87C196CB Specification Update

Automotive

October 1998

Order Number: **273152-002**

1. [Table 10-3. Auto Programming Memory Map, Page 10-2](#)

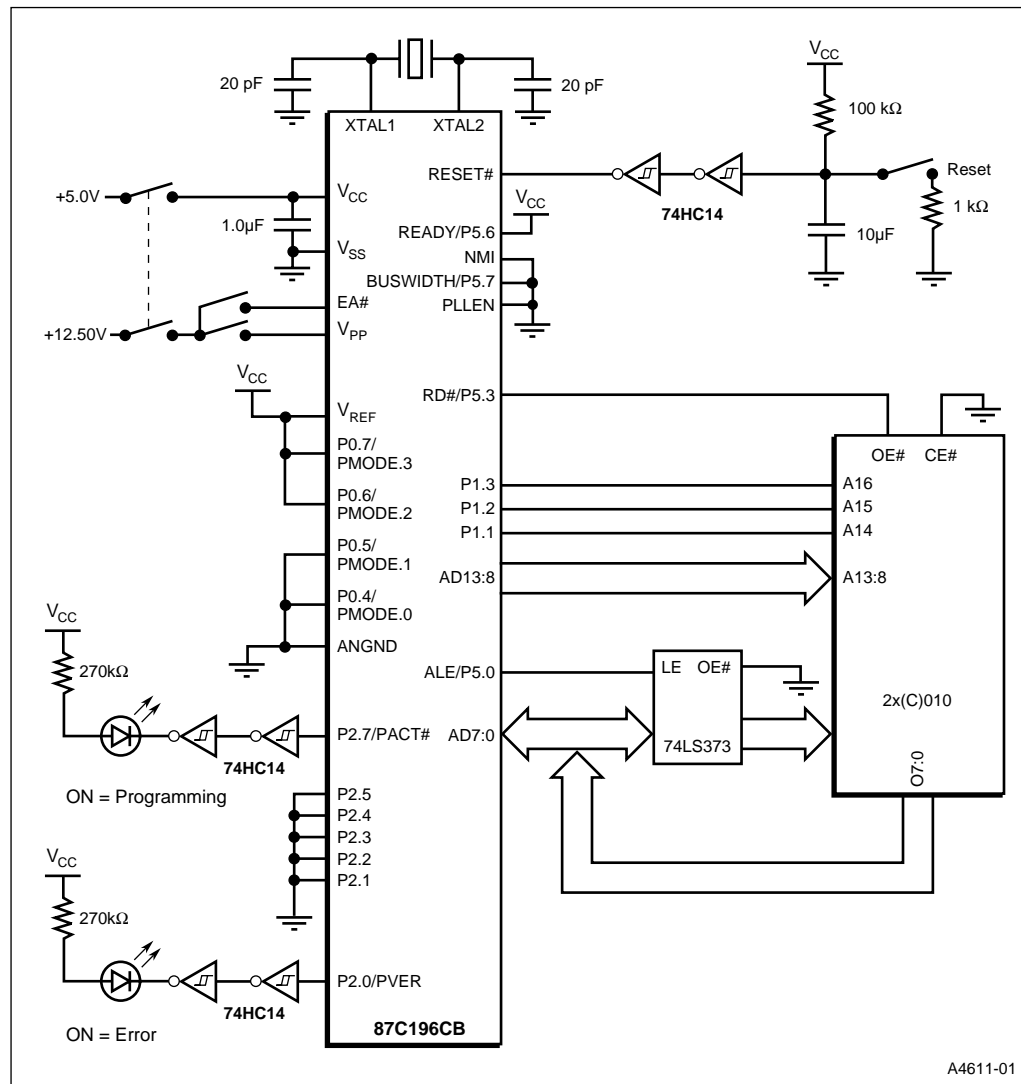
Issue: Corrected programming pulse width (PPW) location.

Changed:

- “4014H” to “405EH”
- “4015H” to “405FH”
- “00014H” to “0005EH”
- “00015H” to “0005FH”

Address Output from 87C196CB (A15:0)	Internal OTPROM Address	Address Using Circuiting in Figure 10-1 (P1.3:1, A13:0)	Description
405EH	N/A	0005EH	Programming pulse width (PPW) LSB.
405FH	N/A	0005FH	Programming pulse width (PPW) MSB.

3. Appendix A; Signal Descriptions

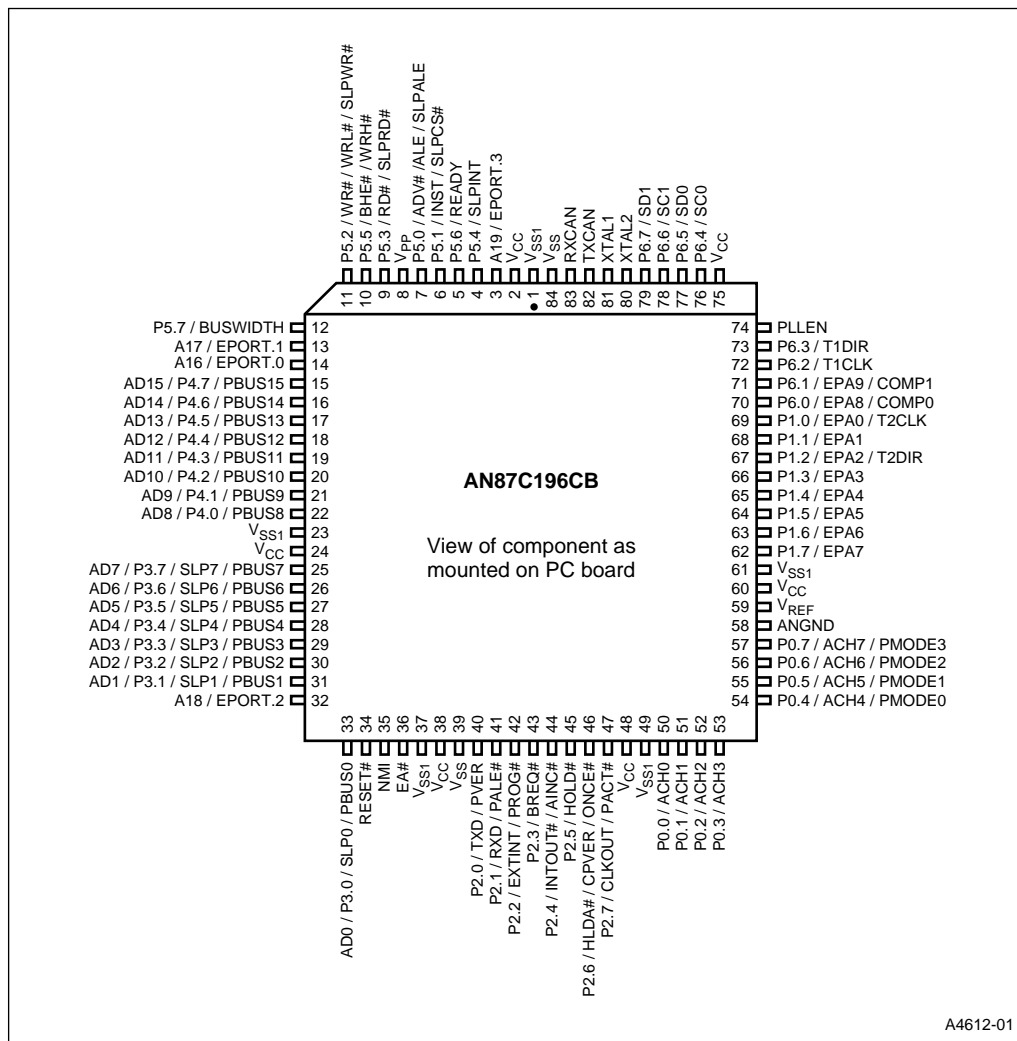
Issue: Figure A-1. 87C196CB 84-pin PLCC package, pin 39:

- WAS - “V_{SS1}”
- IS - “V_{SS}”
